SERVICE LETTER NO. SL115-30

ATA-Code: 76-10
Engine controls support bracket

Possible movement of the mixture control cable can result in a small movement of the throttle lever.

Figure 1

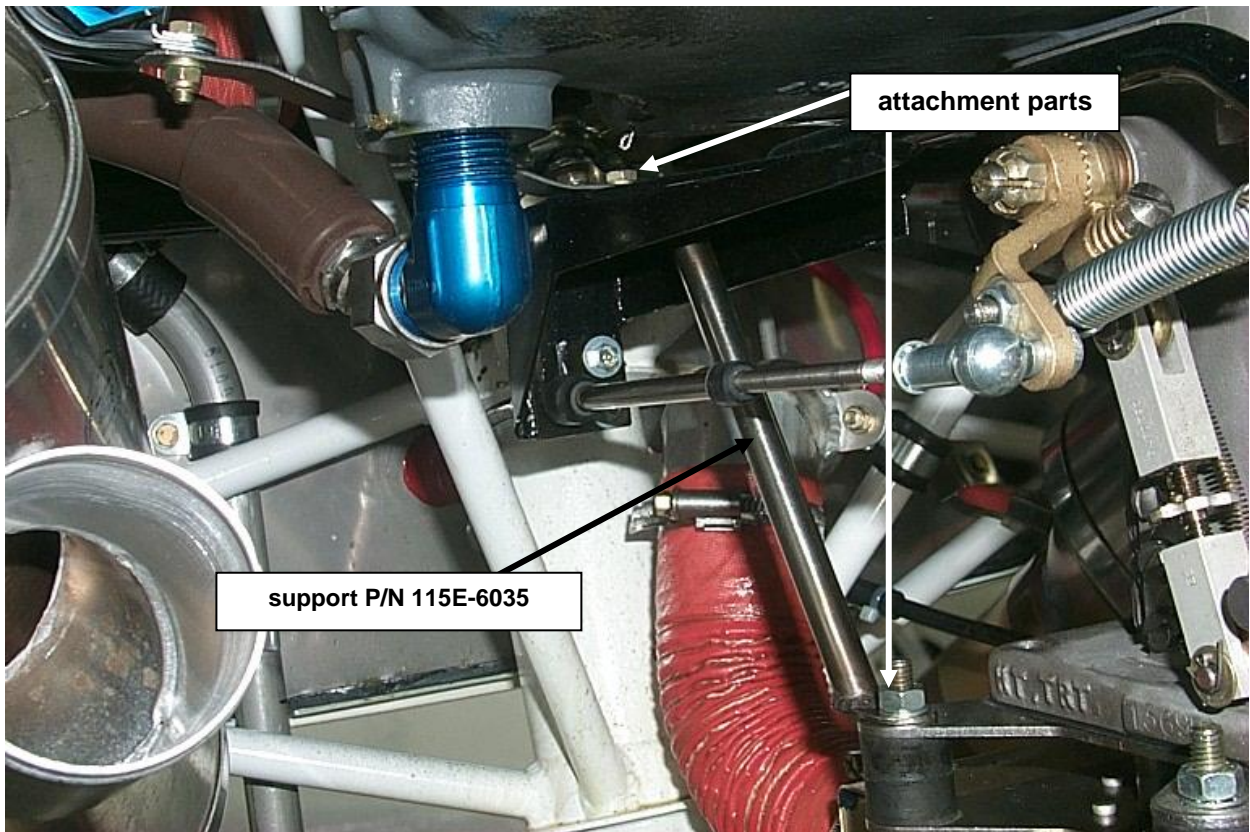
- remove upper and lower cowling IAW Maintenance Manual Chap. 71-10
- remove R/H upper and lower attachment parts IAW figure 1
- install support P/N 115E-6035 and tighten attachment parts
- remove L/H upper and lower attachment parts IAW figures 2 (lower) and 3 (upper)
- install plate P/N 115E-6000.08 and tighten attachment parts
- check/ adjust mixture control cable IAW Maintenance Manual Chap. 76-10
- install upper and lower cowling IAW Maintenance Manual Chap. 71-10
